# COMMONWEALTH of VIRGINIA

DEPARTMENT OF TRANSPORTATION  
1401 EAST BROAD STREET  
RICHMOND, VIRGINIA 23219-2000

January 9, 2004

## MEMORANDUM

502.04

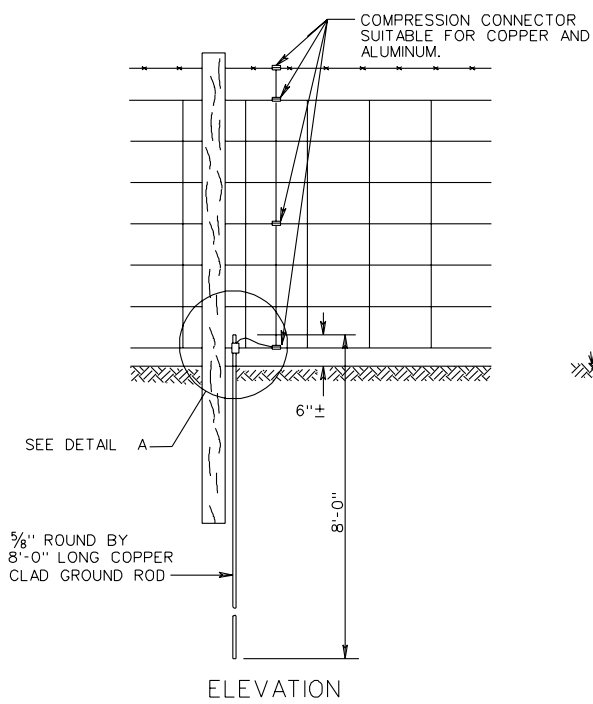
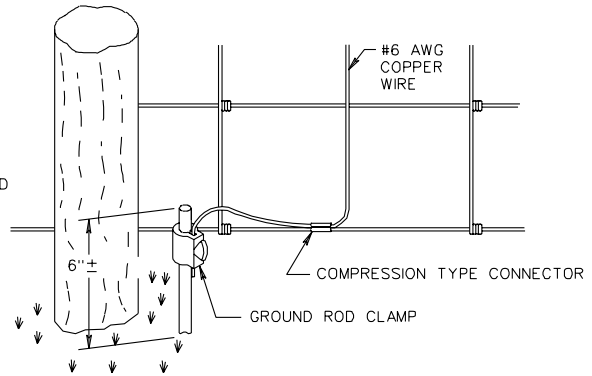
<b>PAGE</b>	<b>INSERT</b>	<b>STANDARD</b>	<b>REVISION</b>
501.56	A96	MB-12A,B,C	Revised flare rates.
501.58	A104	MB-13	Revised flare rates.
502.04	A152	FE-CL	Revised Specification Designation of post sizing.
502.07	A152	FE-6	Revised notes.
603.02	A149	RFD-1	Revised table dimension from Ft. to In.
1301.72	A154	OSS-1	Added Note #6 and revised fixed object offset distance.
1301.73	A154	OSS-1	Deleted catwalks and replaced details with electrical installation details and added a contactor.
1301.74	A155	OSS-1	Replaced details with sign panel erection details and sign lighting details.
1301.75	A155	OSS-1	Replaced details with sign panel erection details and sign lighting details.
